NEW DETERGENT DISPENSER

As of serial number 349 ... (December 2003) a new detergent dispenser with various connections to the salt/rinse-aid probe is being used.

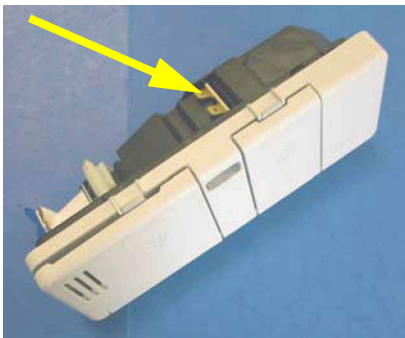
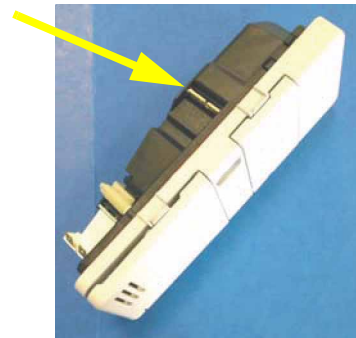
Connection is by means of a connector instead of with two plug-in terminals.

Old detergent dispenser

New detergent dispenser

A special kit for all models is available under spare-part no. 435 255.

The previous detergent dispenser can be replaced with the new one. In order to do so, the special kit must be used. The dispenser must be installed in accordance with the following steps.
